CITY OF ALBUQUERQUE

Re: Palomas Apartments
8320 Palomas Ave. NE
Traffic Circulation Layout
Architect's Stamp 12-23-2021 (D19-D032)

Based upon the information provided in your submittal received 02-11-2022, the above referenced plan cannot be approved for Building Permit until the following comments are addressed:

OVERALL SITE PLAN - PALOMAS APARTMENTS

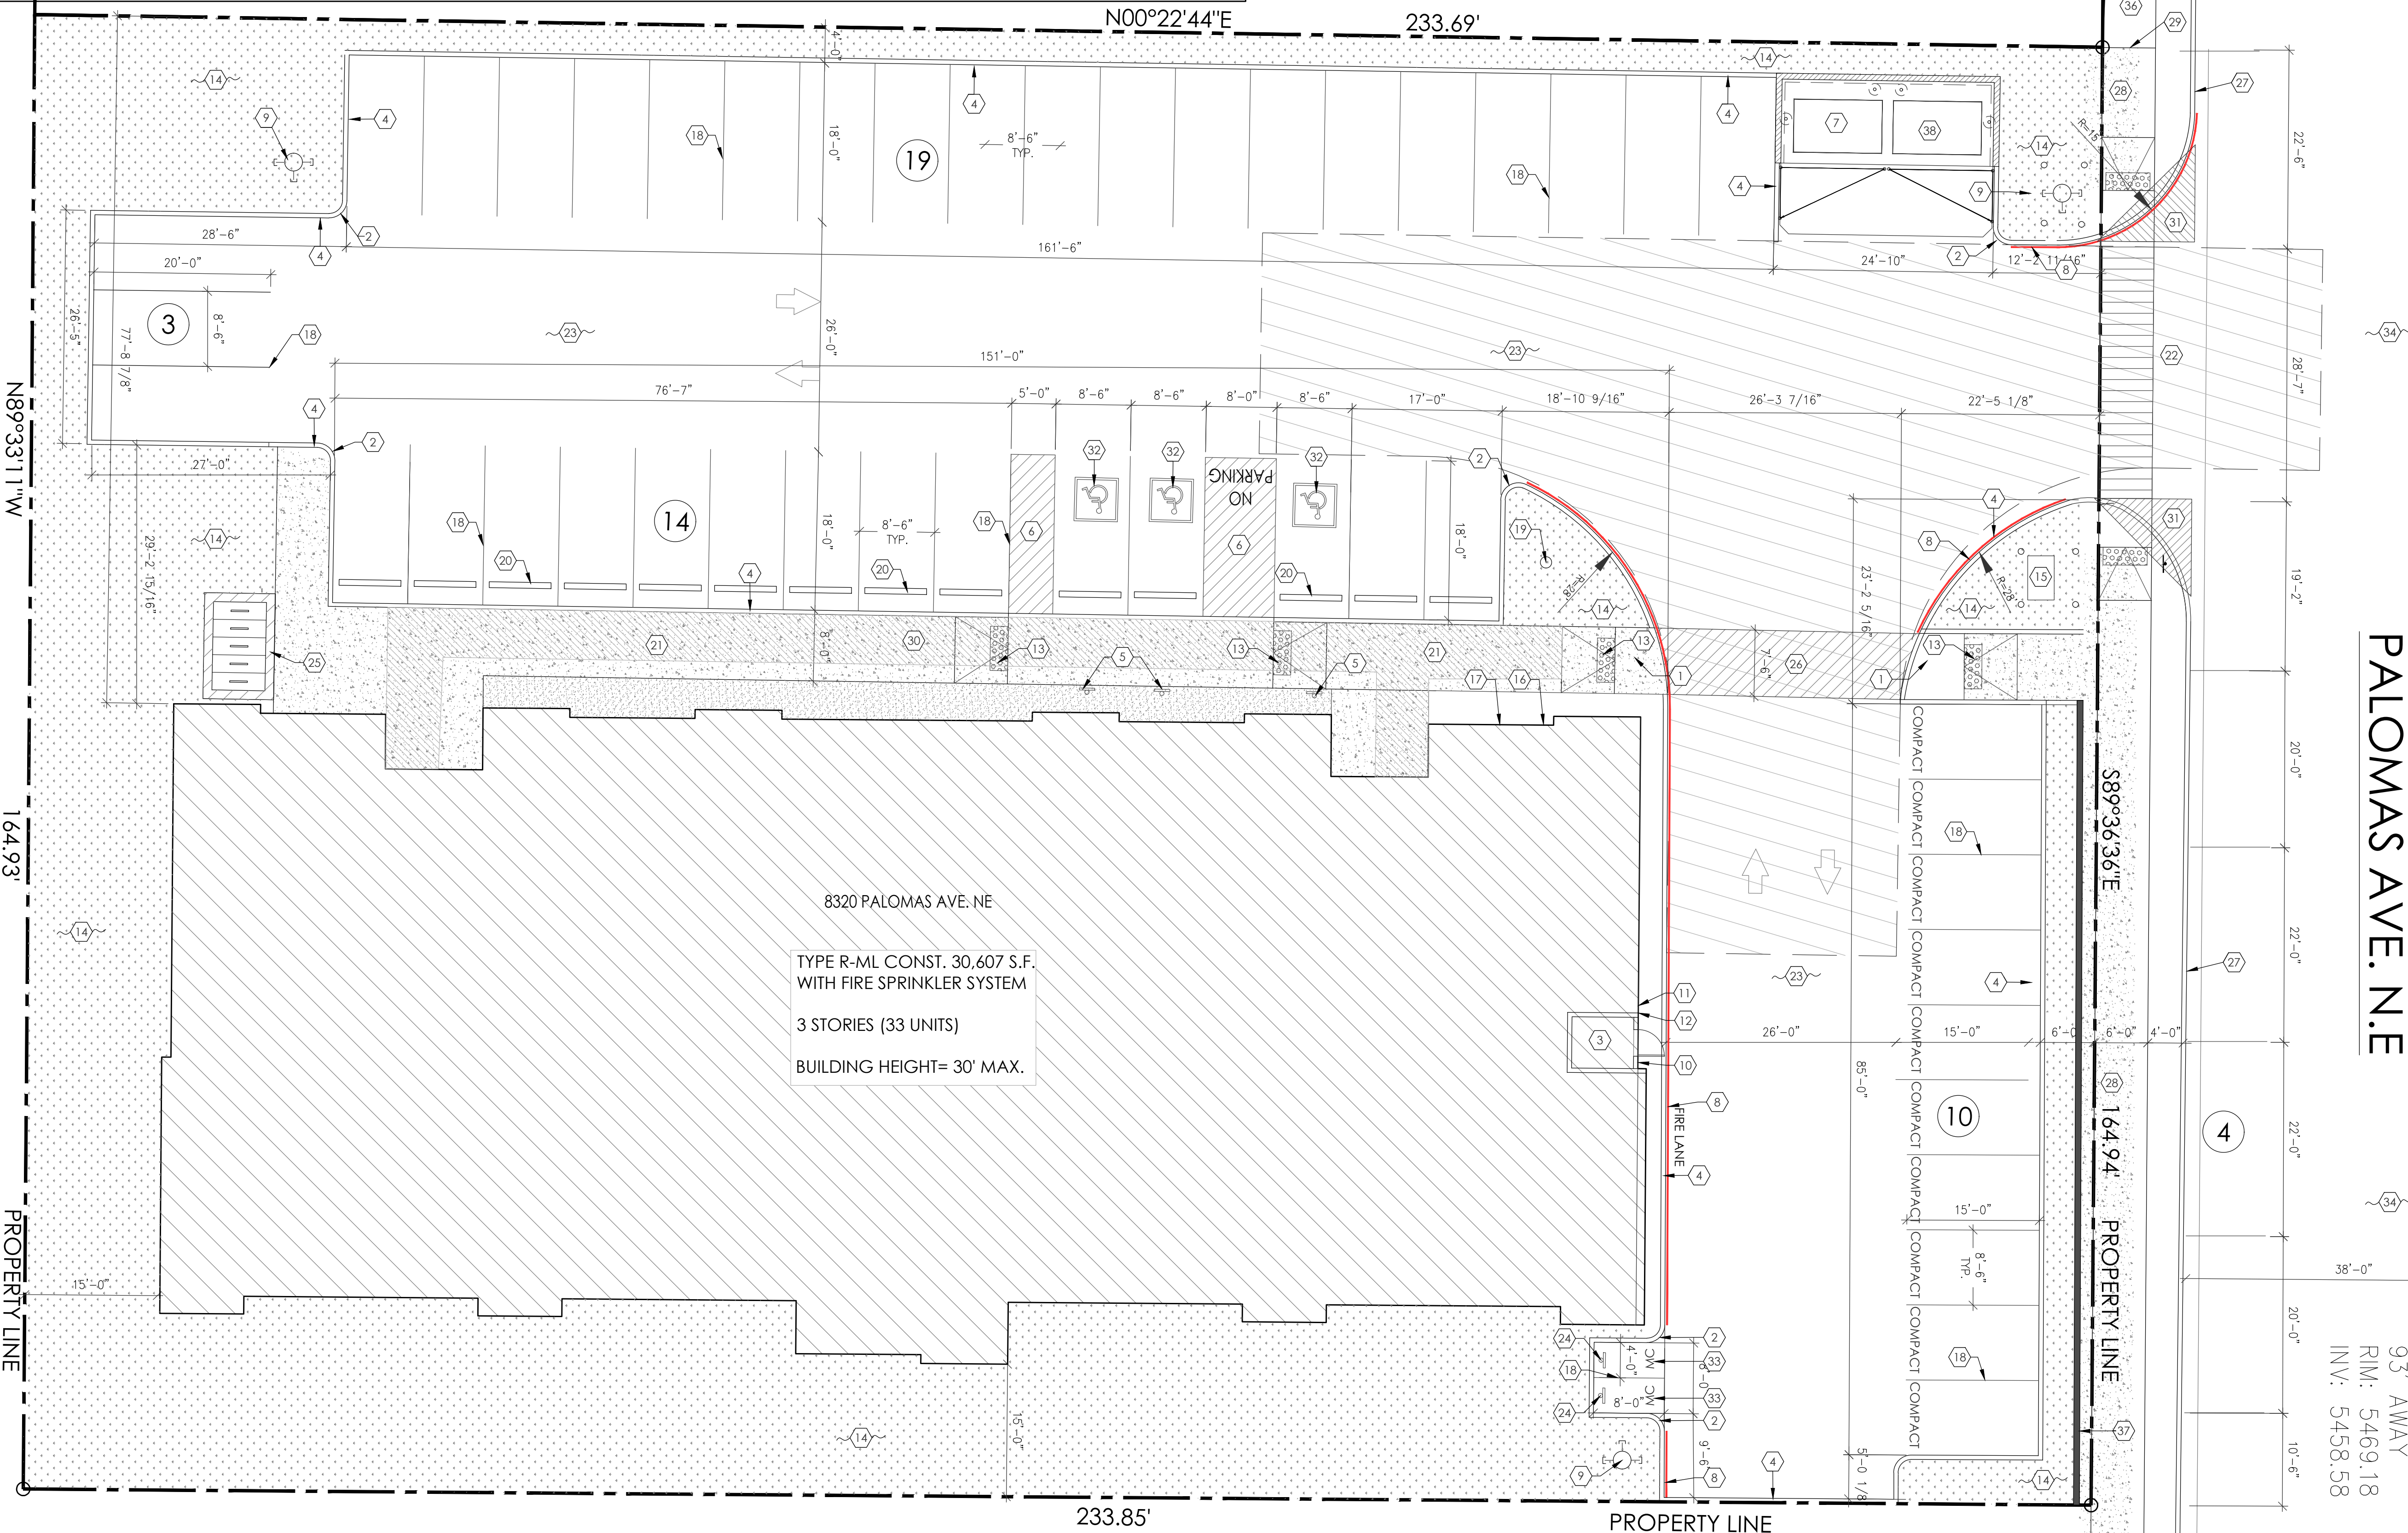
1. Please revise ADA ramp details. Cross slope should be 2%max.
2. Construction new drivepad per COA std dwg 2426. Please add a note (Parallel Ramp option).
3. Key note 30 is missing.
4. Provide a copy of Fire Marshal and Solid Waste Approval.
5. **Keyed Note 29:** Explain why are you using COA std Dwg 2432?
6. A sidewalk easement will be needed for sidewalk located outside of public ROW
